**BRYAN CITY SCHOOLS**  
**Administrative Office Renovations**  
Bryan, Ohio

B7-4565

## **ADDENDUM NO. 2**

1 DEVELOPMENT PLAN  
C-1 SCALE: 1"=50'

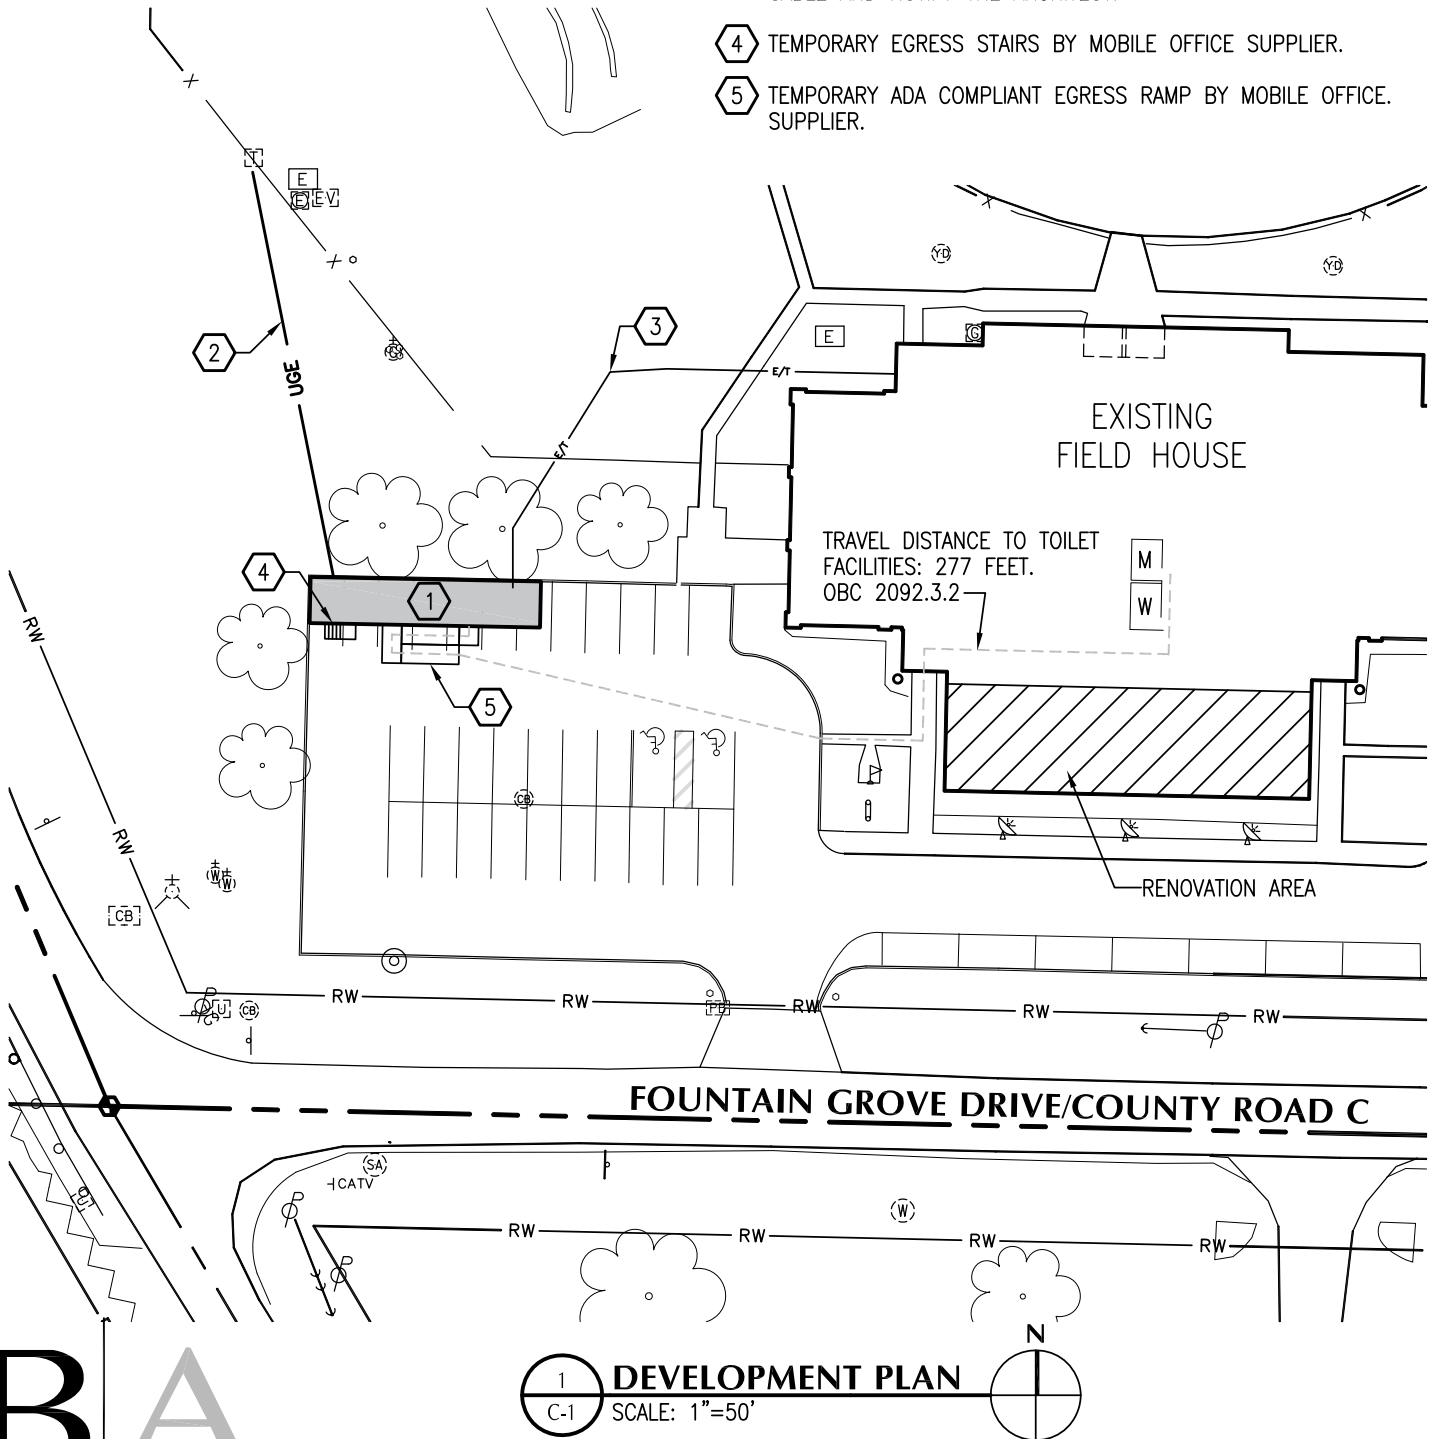
See attached sketch C-1b for revised location of temporary office trailer. Disregard trailer foundation detail issued under Addendum 1. Locate trailer on existing asphalt parking lot. Protect asphalt surface by placing ABS pads under all CMU supports. Patch asphalt at all tie-down locations following trailer removal.

2 HVAC PLAN  
SCALE: 1/8"=1'-0"

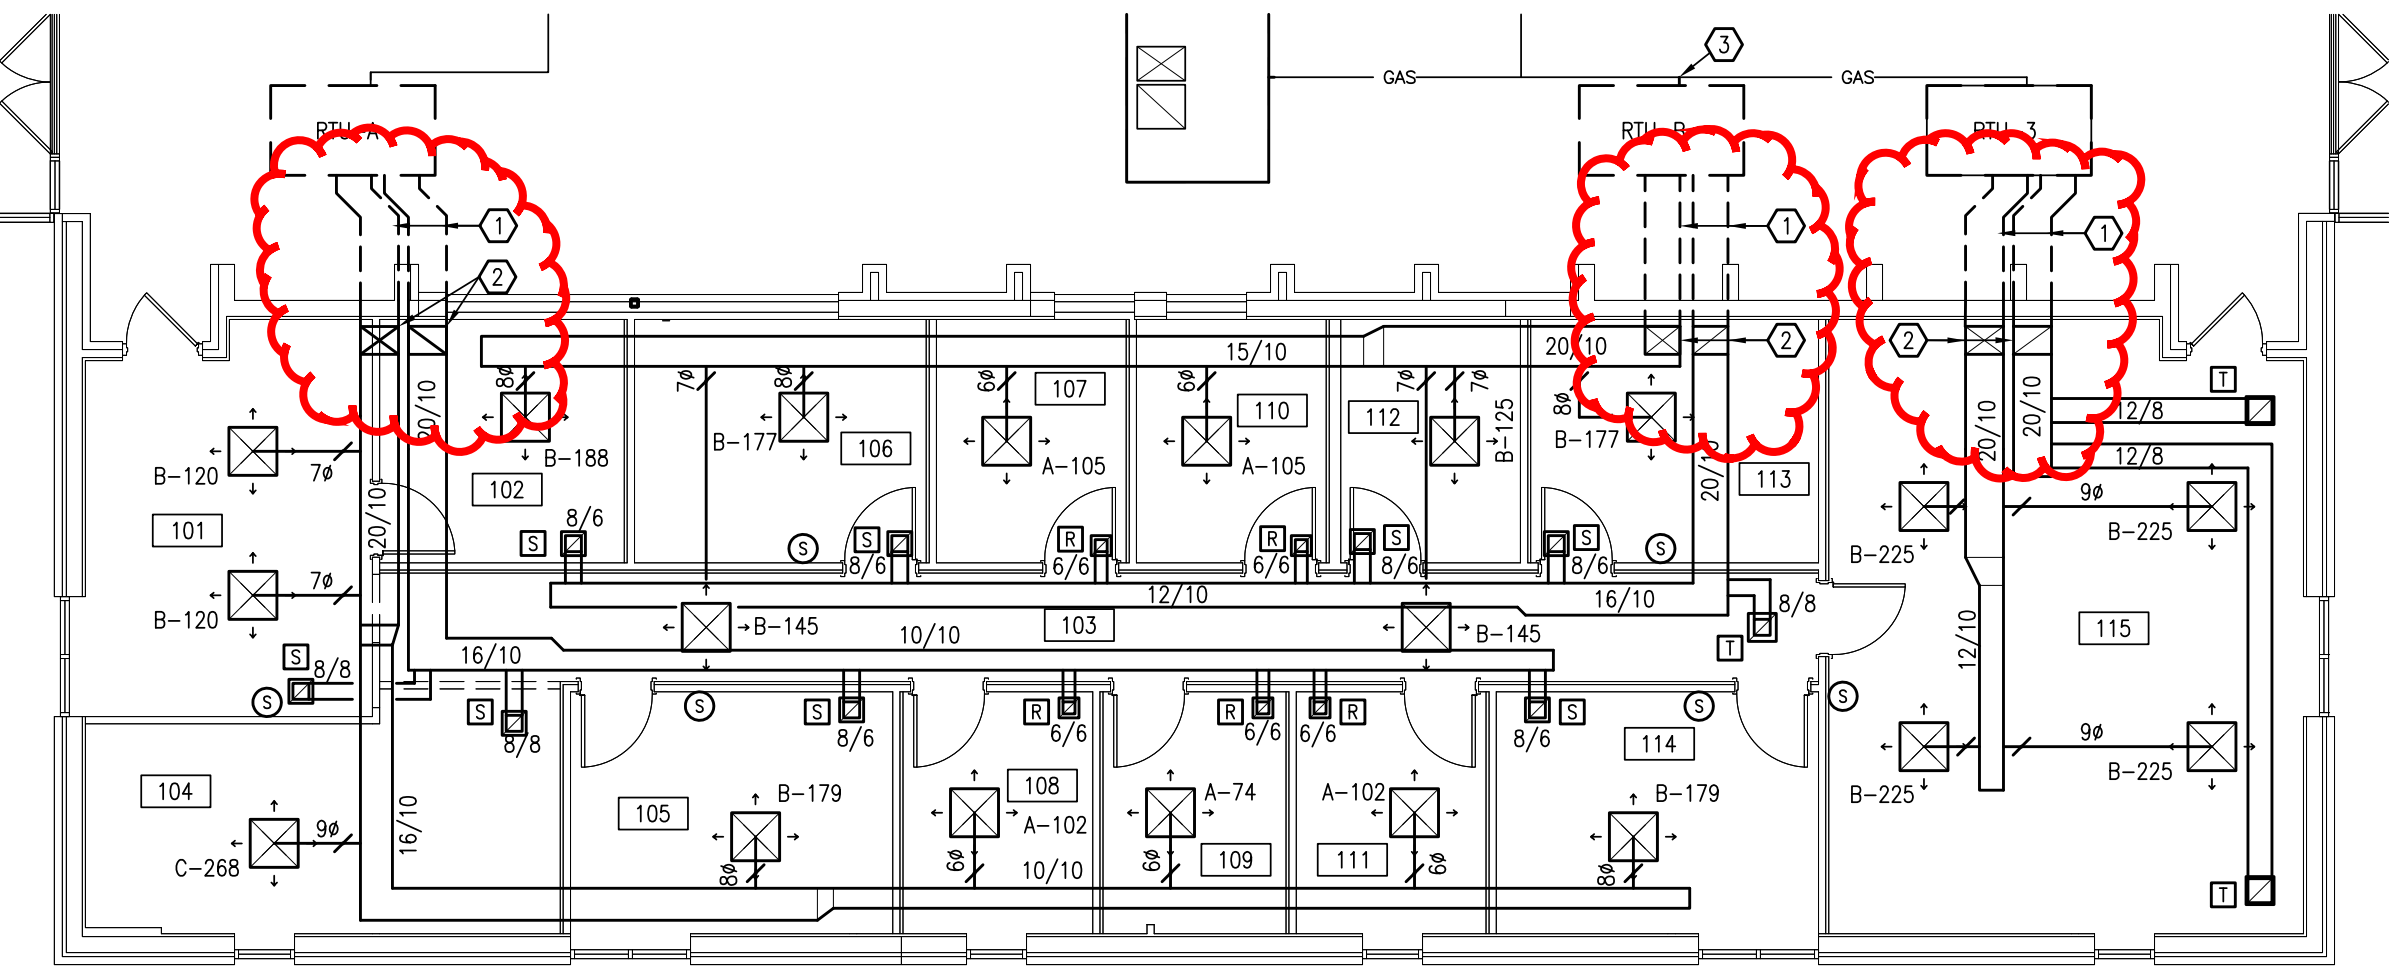
See attached sheet M-1 for revisions to ductwork.
